SERVICE BULLETIN #57

DATE: 11 May 1987

SUBJECT: Main Rotor Pitch Link Inspection & Fitting Replacement

FIGURE 1 CRACK LOCATION

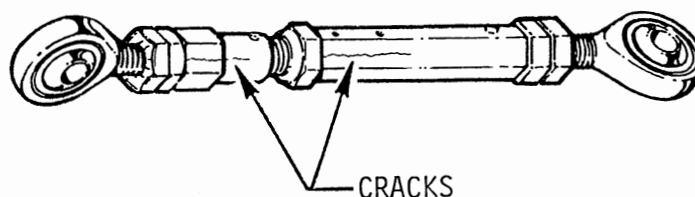
1. Visually inspect the Main Rotor Pitch Links for cracks using 3X or greater magnification. Pay particular attention to any crack or crack-like indication that runs lengthwise of the A258-2 upper fitting or the hexagon shaped A258-3 lower link.

2. If any crack indications are found, immediately ground the helicopter and perform Part B prior to any further flight.
3. Part A may be accomplished by a pilot or mechanic and must continue until Part B is accomplished.

FIGURE 2 MAIN ROTOR PITCH LINK

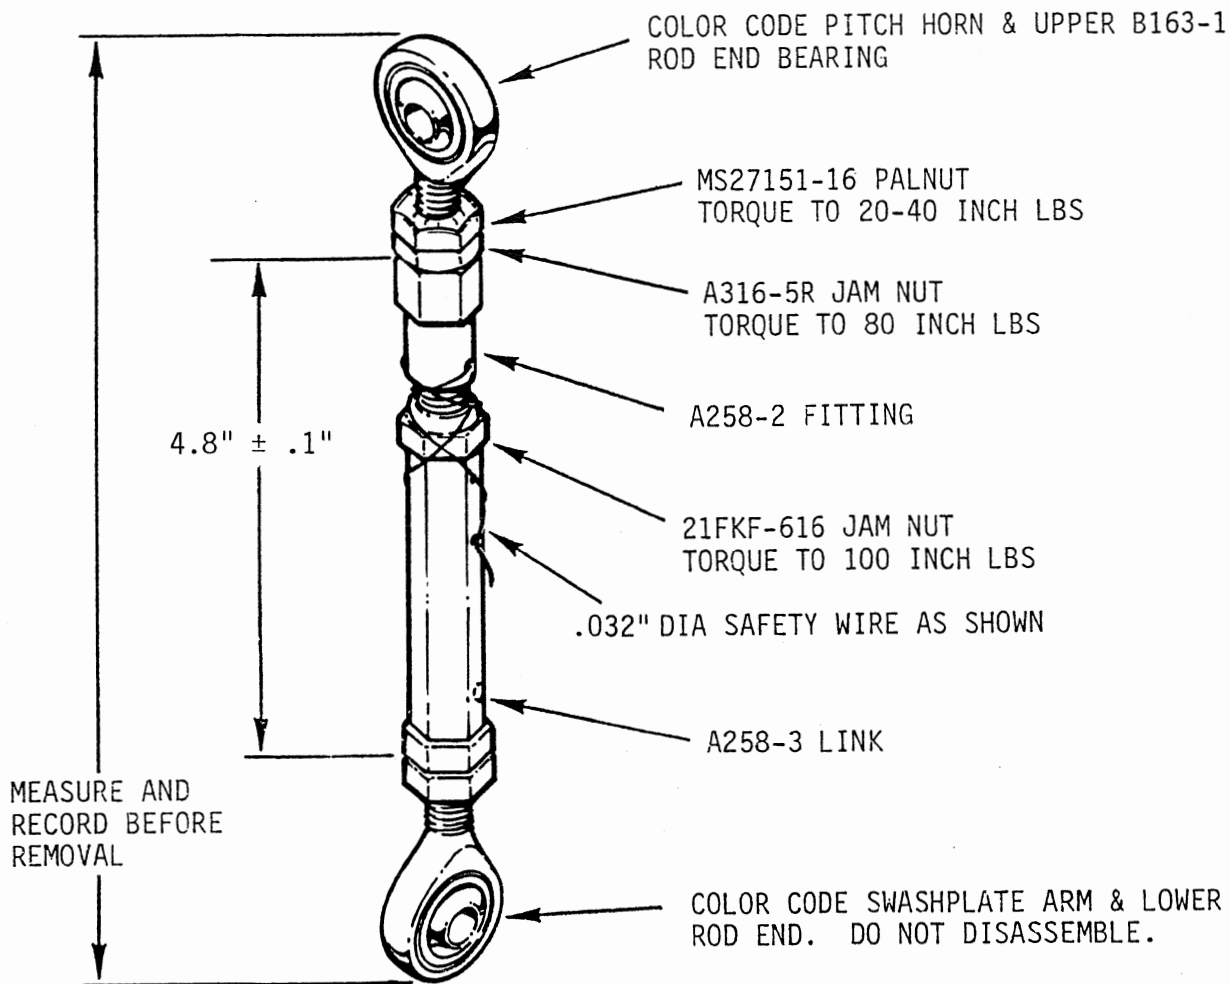
1. Order replacement A258-2 Fittings from RHC, two required per aircraft.
2. When replacement parts are received, install per Steps 3 thru 10.
3. Color code swashplate arms, pitch horns, and both pitch link rod end bearings.

4. Remove pitch links and measure overall length using a caliper or large micrometer. Record length to nearest .001 inch.
5. Disassemble pitch links. Do not remove lower rod end bearing. Replace A258-2 fittings.
6. Remove paint and visually inspect the A258-3 links using a 3X or greater magnification; if any crack indications are found, replace complete A258-1 Pitch Link assembly.
7. Red tag replaced Fittings and any defective Links and return to RHC for warranty credit.
8. Reassemble pitch links as shown in Figure 2. Keep overall length to within $\pm .005$ of length measured before disassembly.
9. Install on helicopter and torque attaching bolts to 100 inch-lbs. See Section 8-412 of Maintenance Manual.
10. Touch up paint using an epoxy primer and grey exterior paint. Torque strip all joints. Final inspect and make appropriate log book entry.

If matching color marks are lost or length of pitch link changes, a track and balance per Section 10.200 of the Maintenance Manual will be required.
